REVISED RESPONSE TO REQUEST FOR ADDITIONAL INFORMATION**APR1400 Design Certification****Korea Electric Power Corporation / Korea Hydro & Nuclear Power Co., LTD****Docket No. 52-046****RAI No.: 318-8337****SRP Section: 15.06.05 – Loss of Coolant Accidents Resulting From Spectrum of Postulated Piping Breaks Within the Reactor Coolant Pressure Boundary****Application Section: 15.6.5****Date of RAI Issue: 11/24/2015****Question No. 15.06.05-2****SBLOCA Break Spectrum Analysis & Core Two-Phase Level**

Response – (Rev. 1)

Figure 15.6.5-25A 126.7cm² (0.1364ft²) Break in Pump discharge Leg:
Normalized Total Core Power

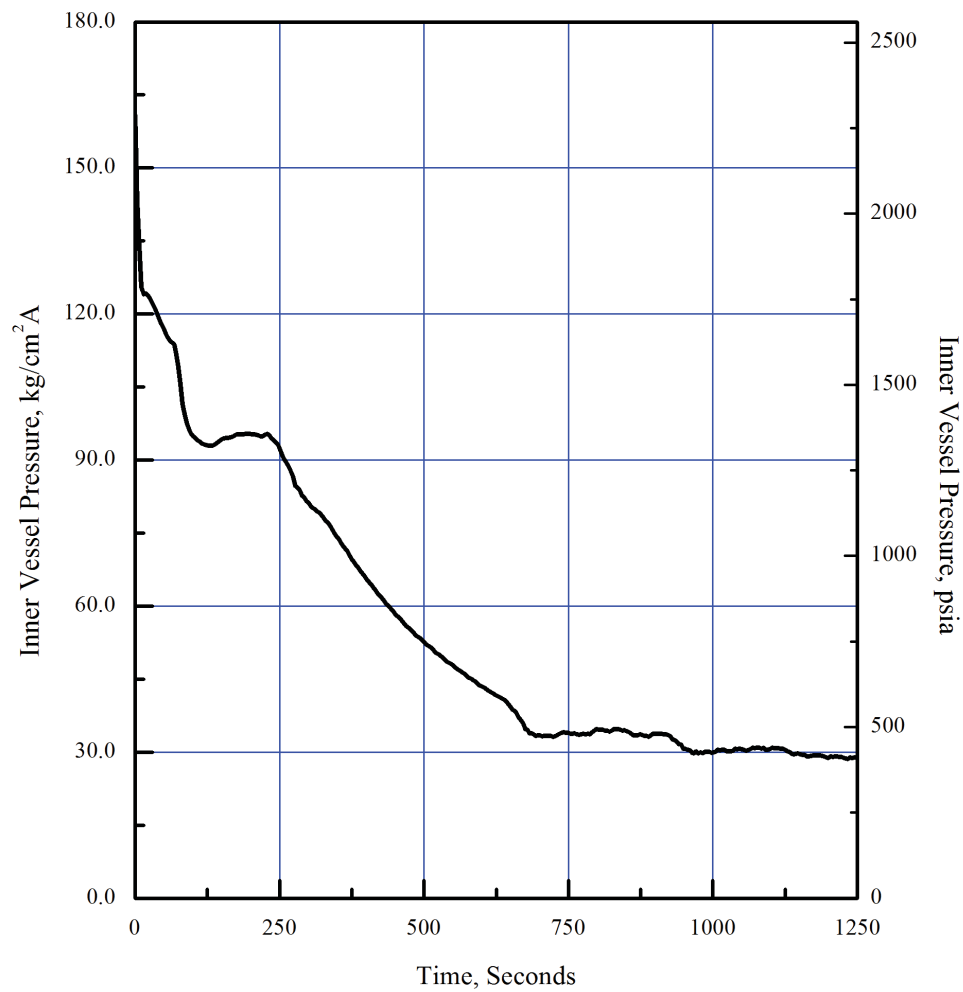
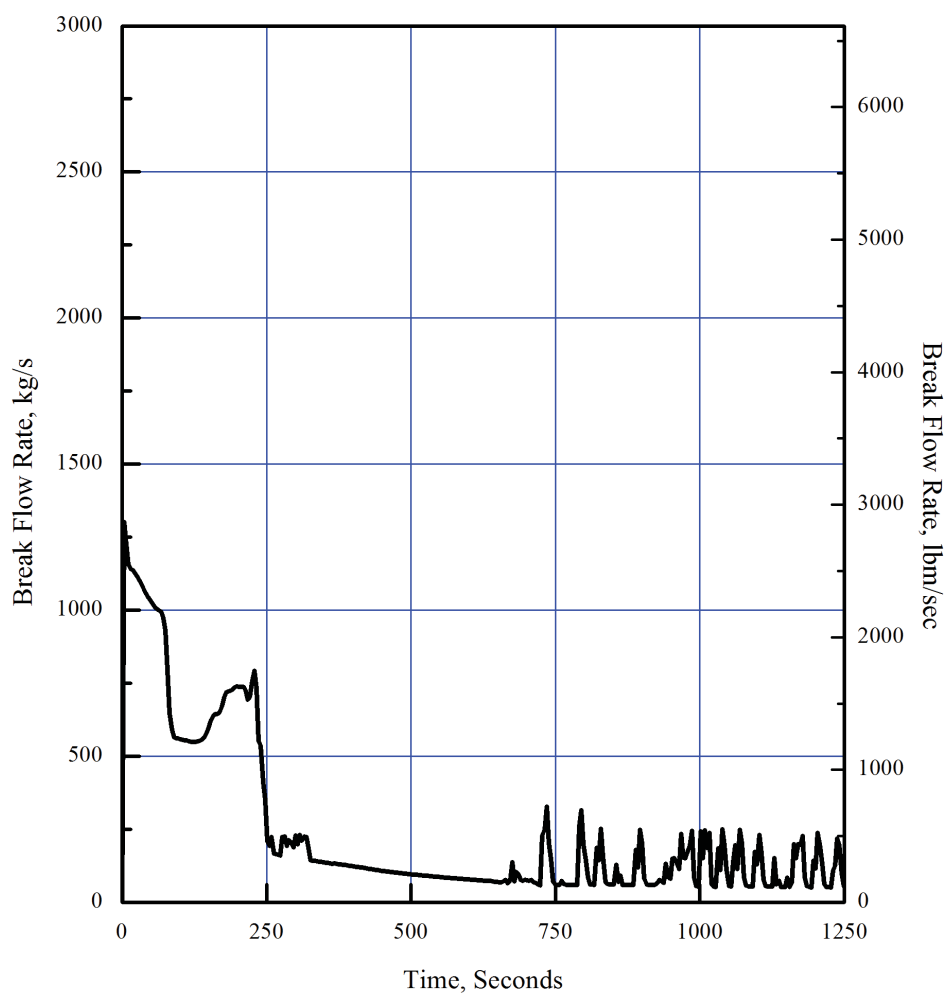
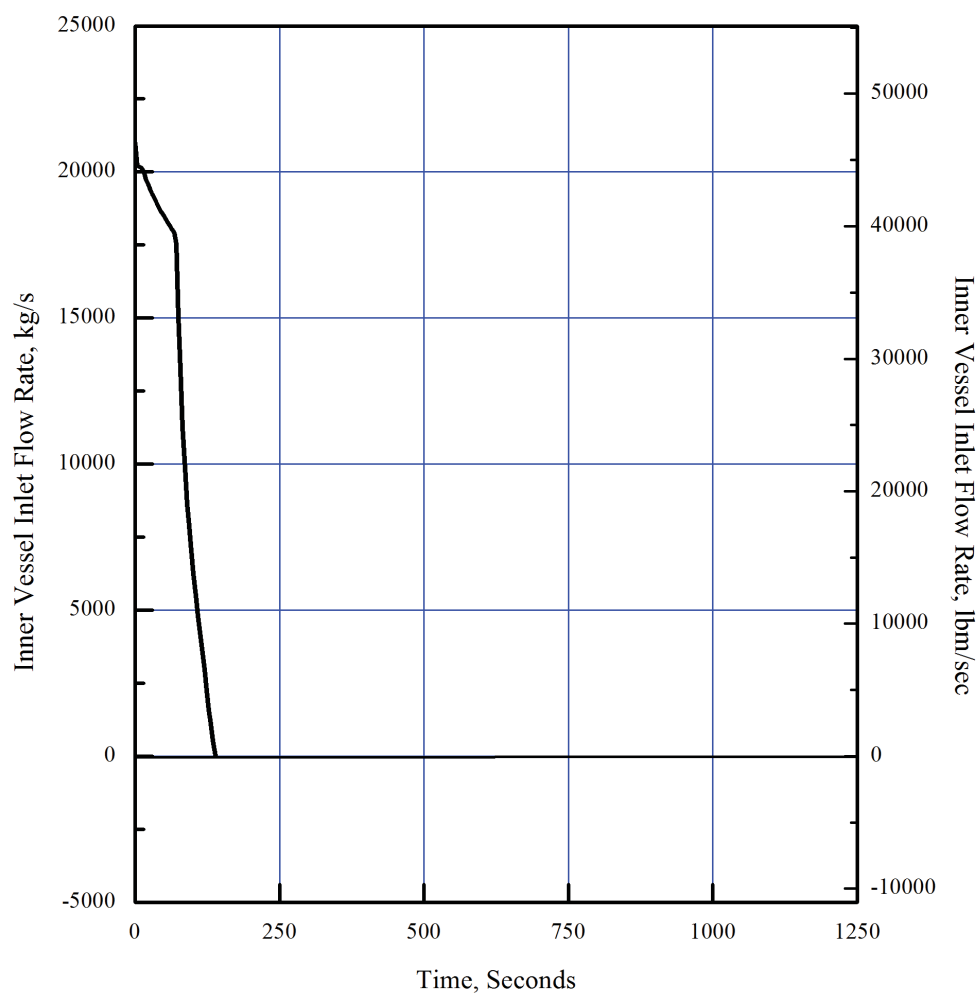
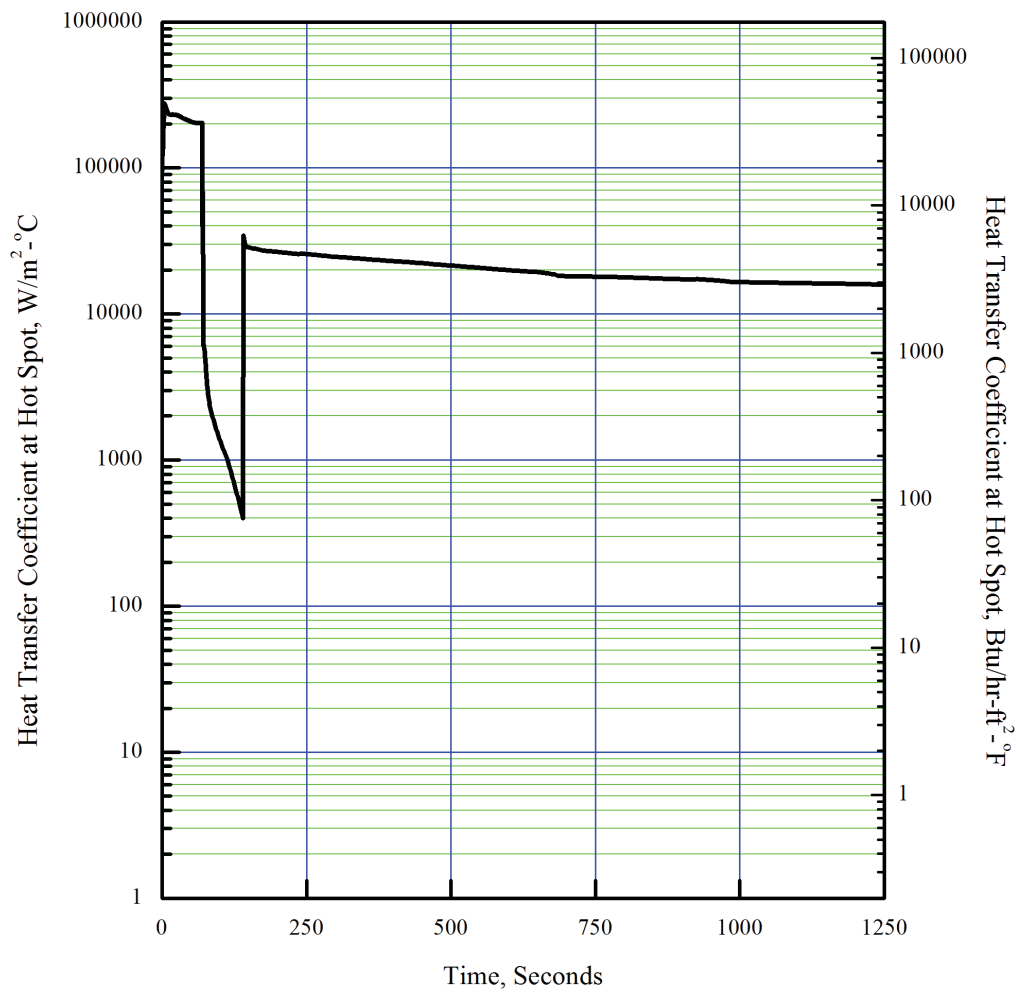
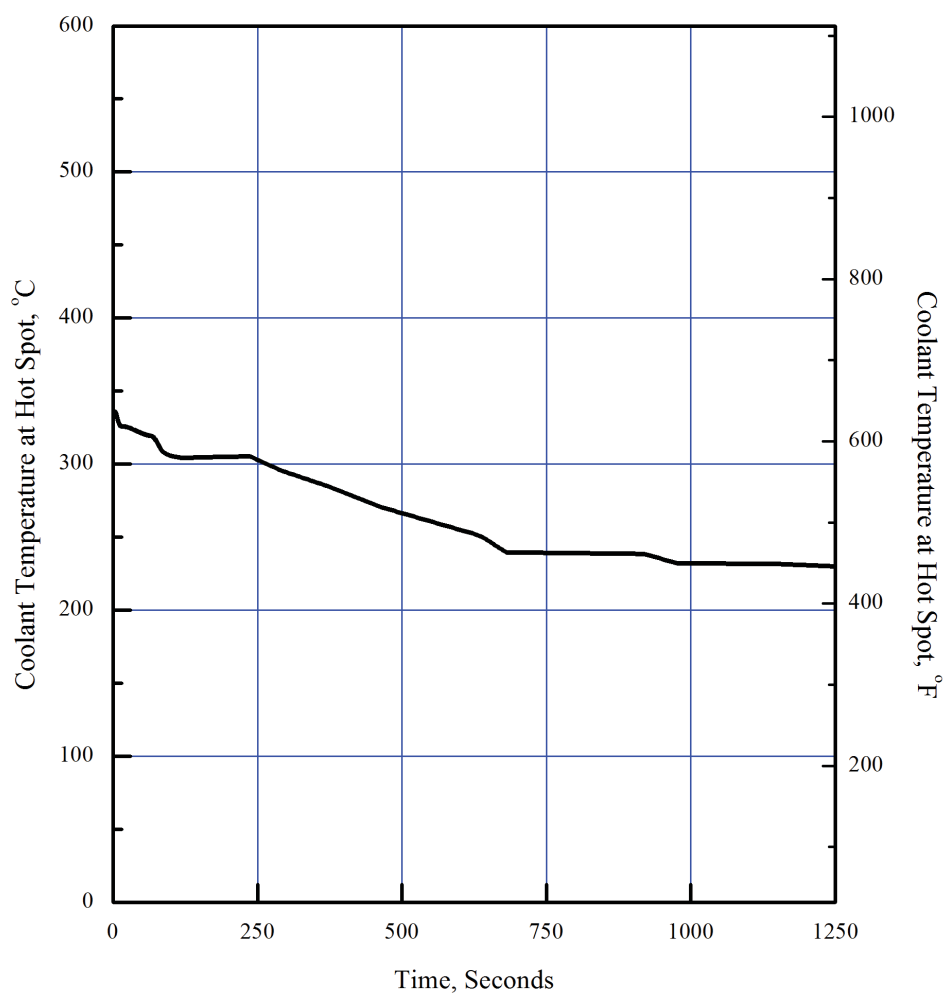
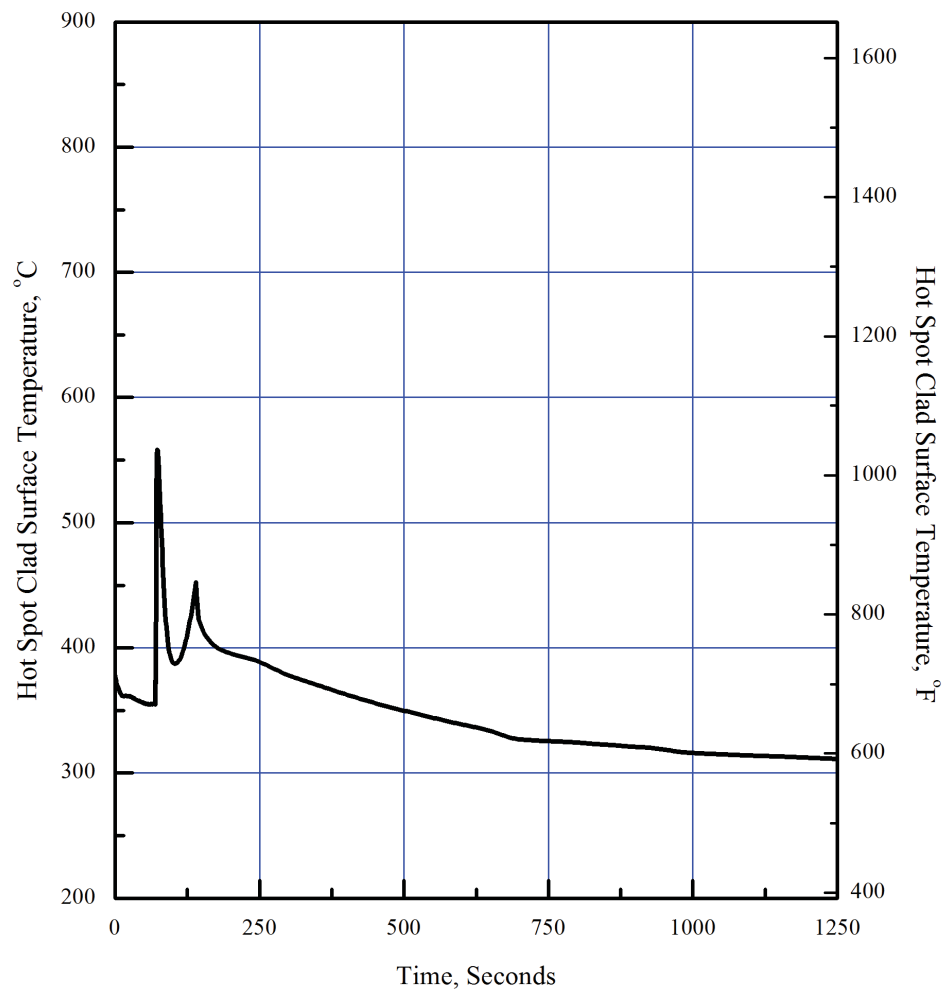
Replace with A

For the cold leg breaks, the additional SIS flow resulting from being able to credit two SIPs precludes core uncover to break sizes up to ~~93 cm² (0.1 ft²)~~. In addition, the core

uncovery for break sizes greater than ~~93 ft² (0.1 ft²)~~ is delayed, and the depth and duration of uncovery decreased relative to DVI breaks, which credit only one SIP. This more favorable behavior results in lower cladding temperatures relative to breaks in a DVI line.
